**GUADALUPE-BLANCO RIVER AUTHORITY  
REGIONAL WASTEWATER FACILITY  
PLANNING STUDY  
EASTERN HAYS COUNTY, TEXAS**

PBS&J  
6504 Bridge Point Parkway  
Suite 200  
Austin, Texas 78730-5091

August 2005

**Figure 2-1**  
**CCN: Water**

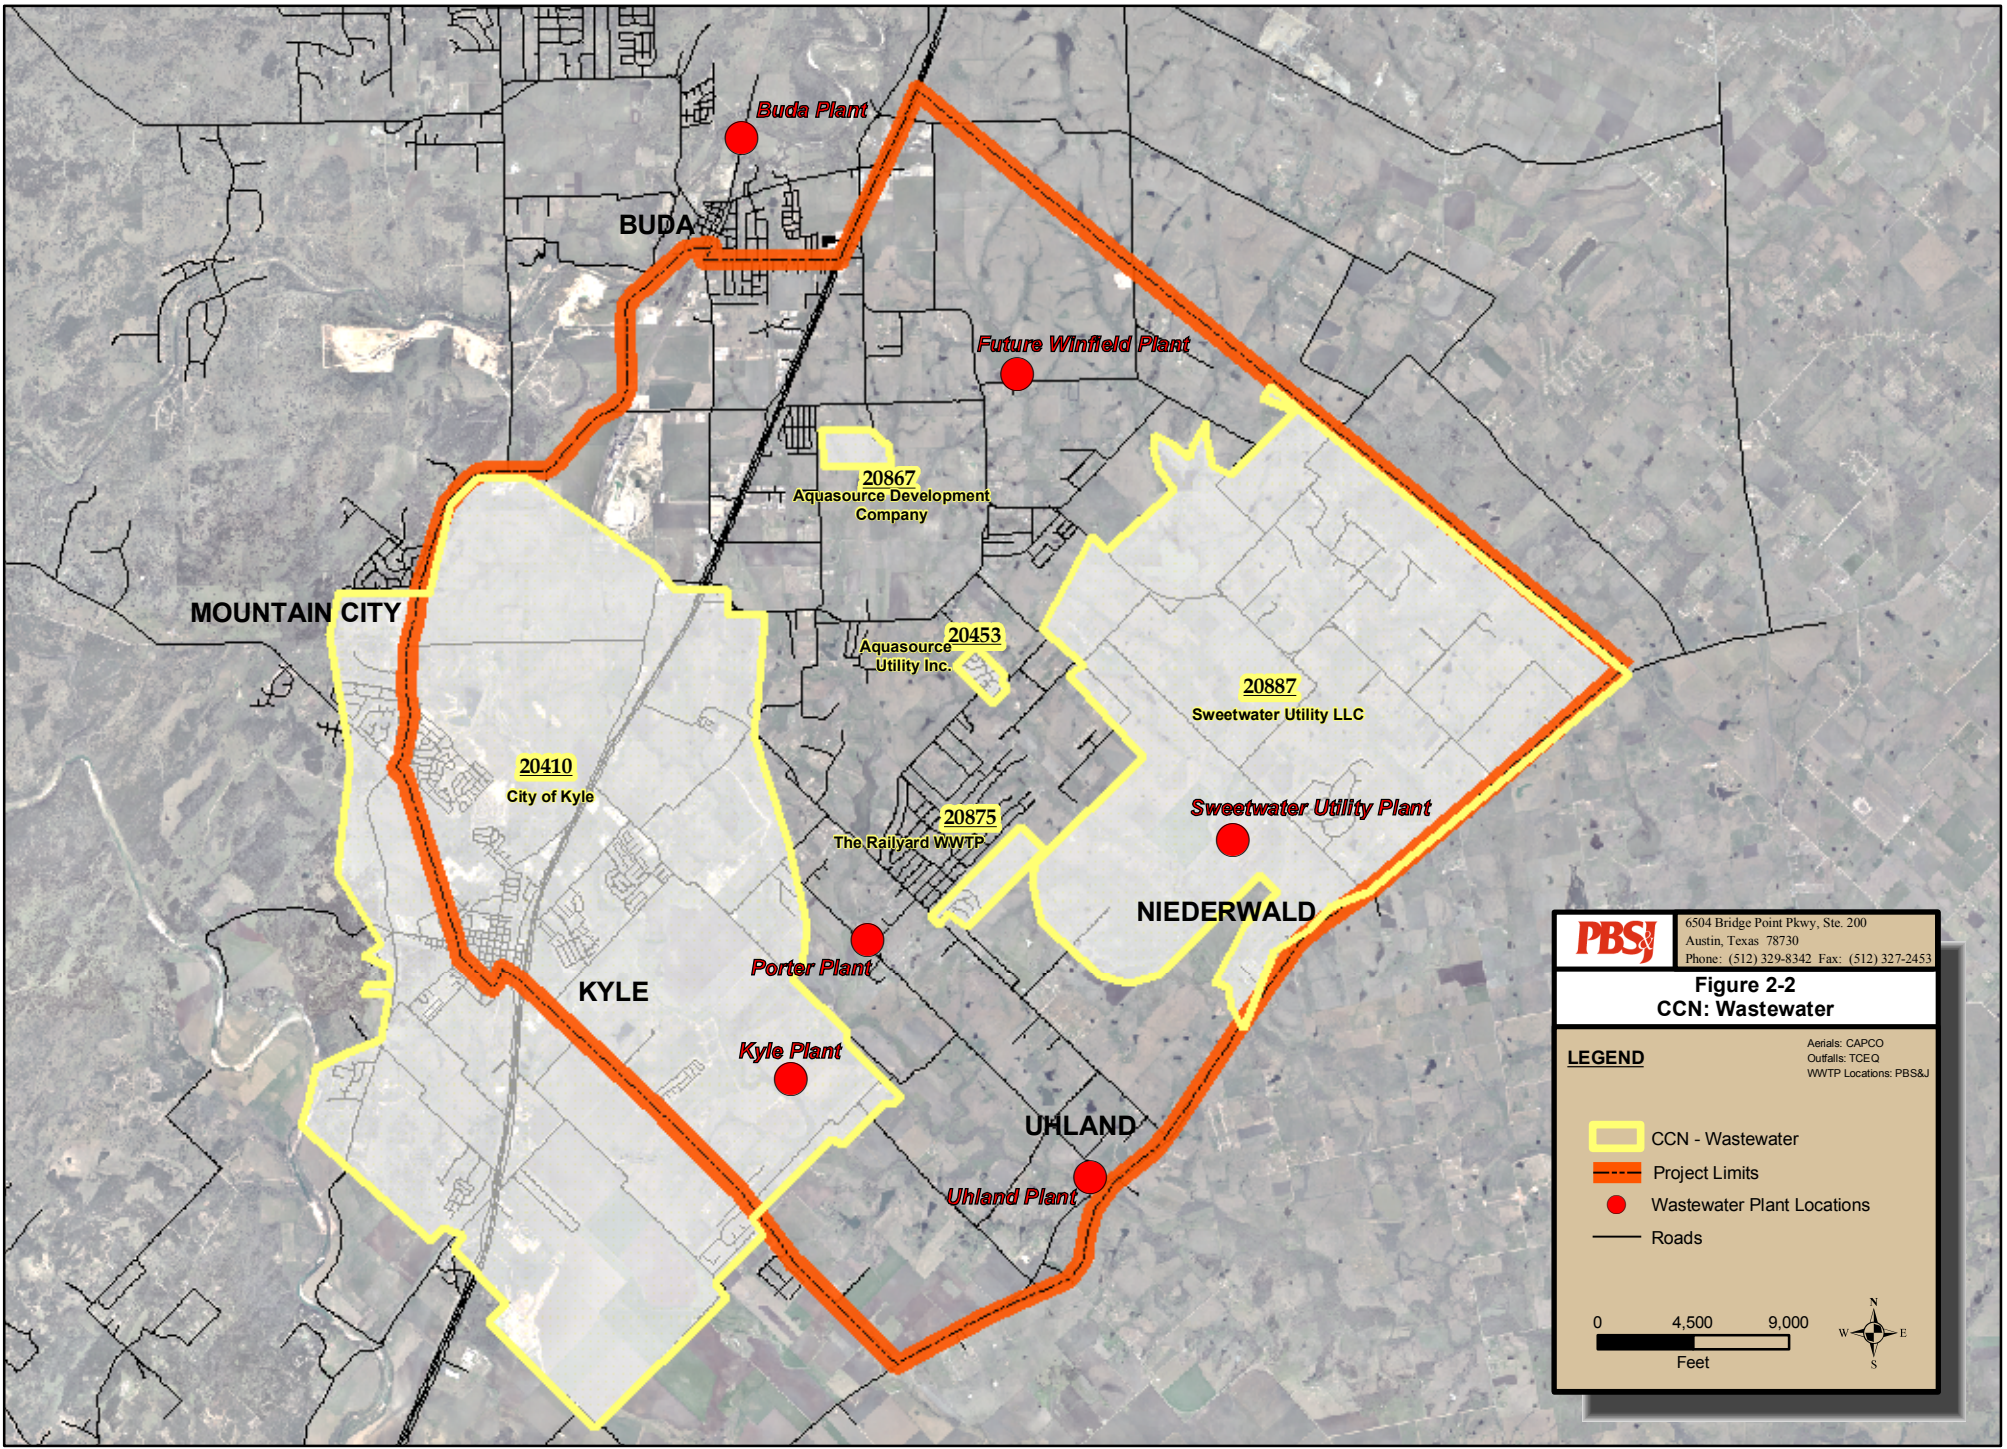
4. On page 2-4, the report states that, "A map identifying land use types and locations can be seen in Figure 2-1." Figure 2-1 delineates CCN boundaries for water supply. The report text and figures should be consistent.

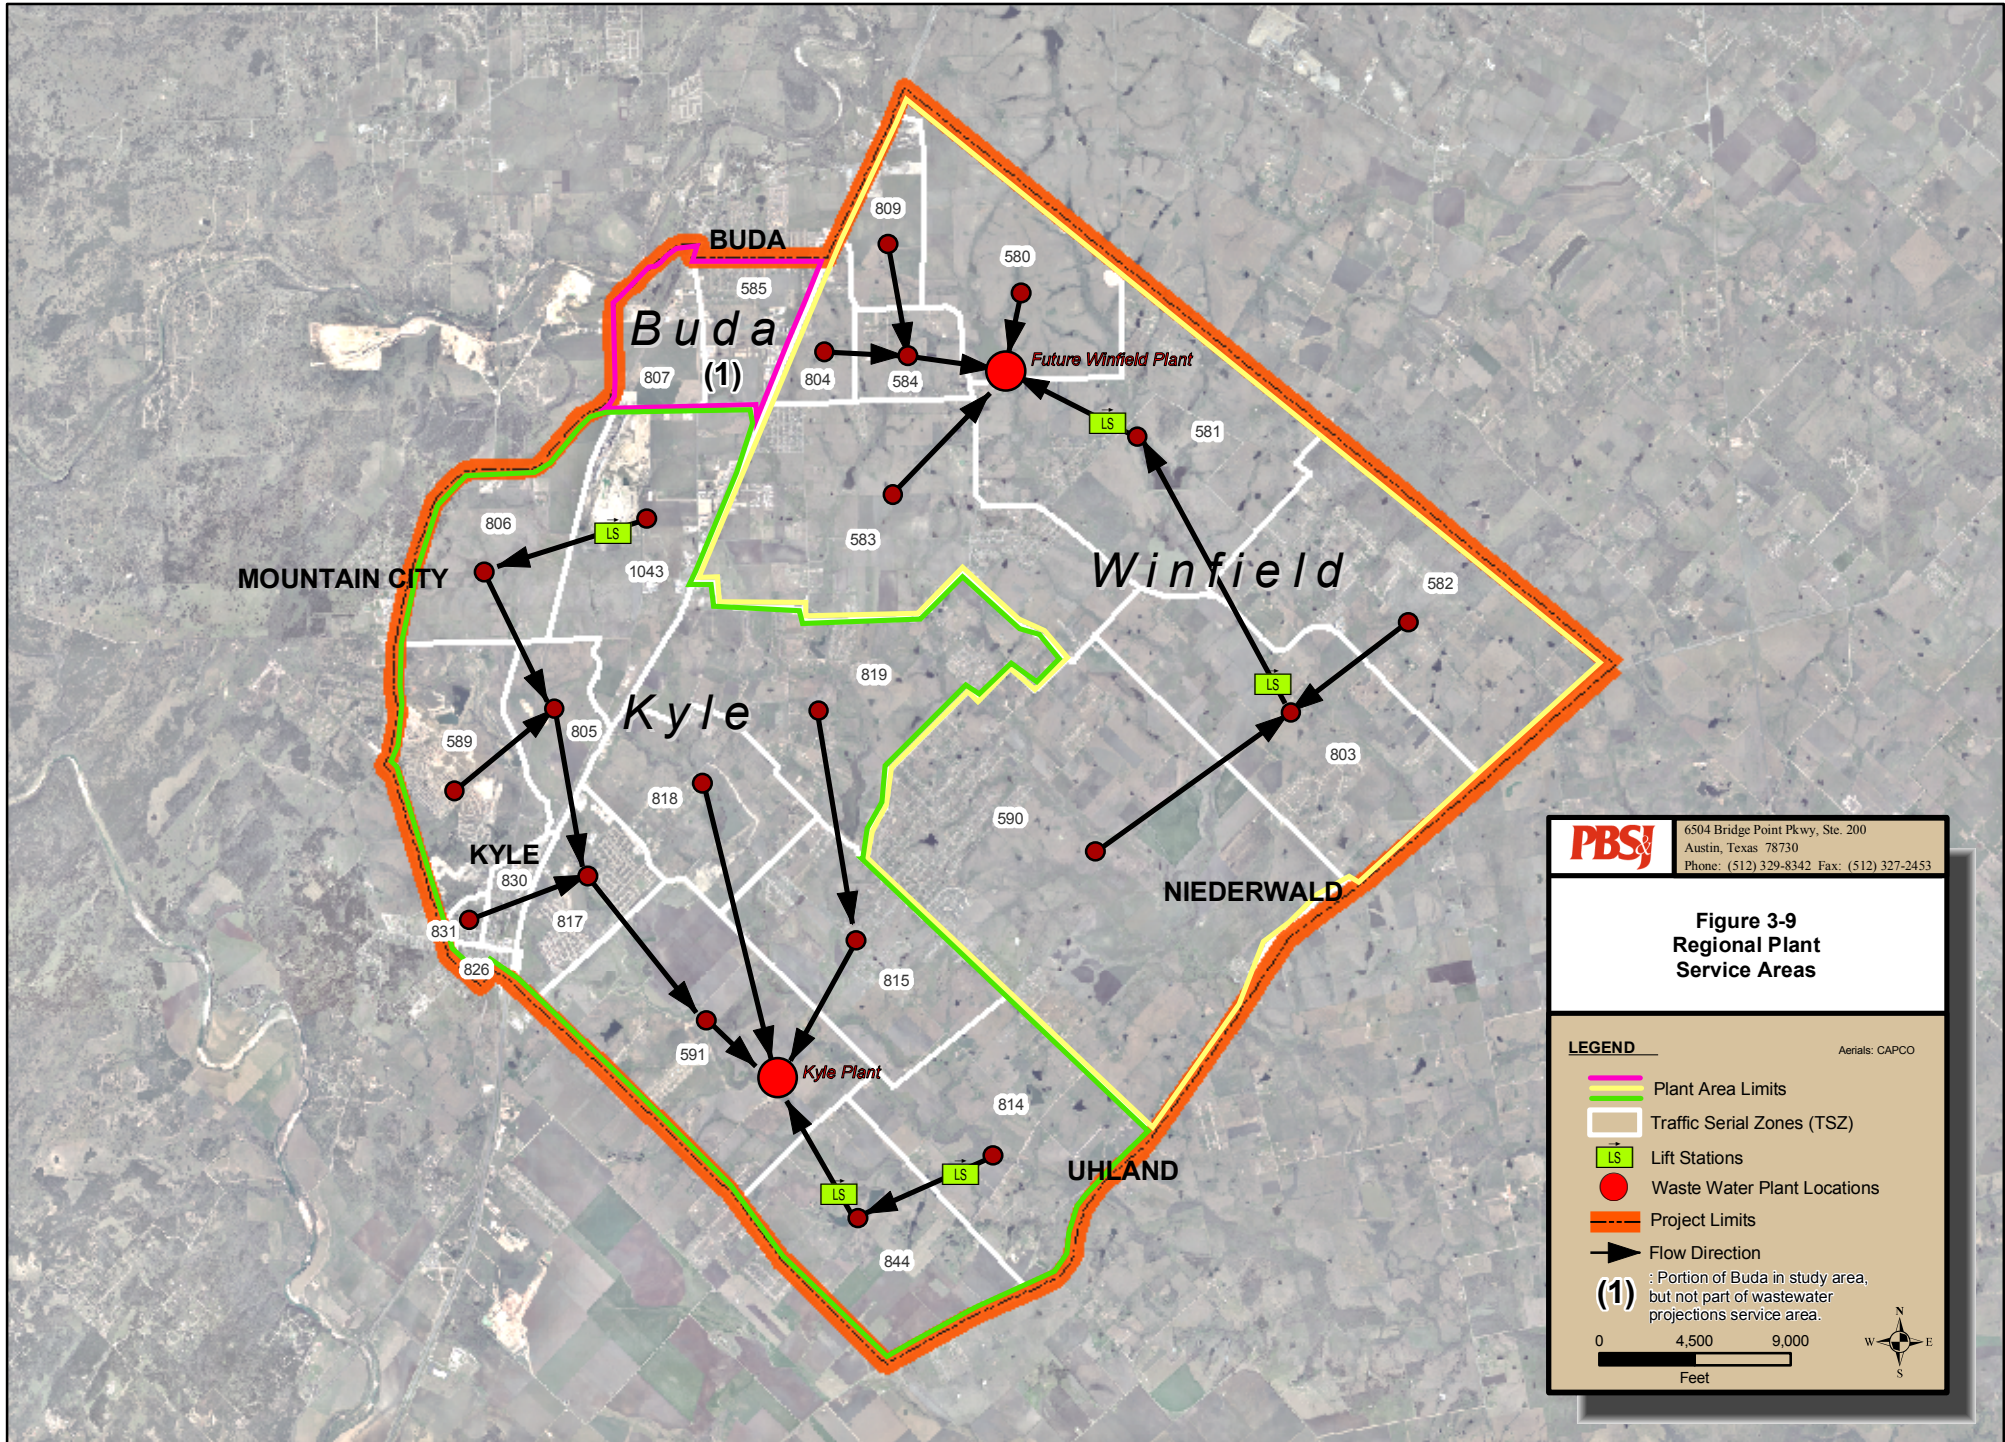
7. On page 3-19, in 3.4.2, the report states that, "The two plant models utilized existing plants for wastewater treatment and are separated by a ridgeline which divides the planning area....TSZs served by each plant can be seen in Figure 3-9." Figure 3-9 shows the locations of an existing Kyle plant and a future Winfield plant. The report text and figures should be consistent.
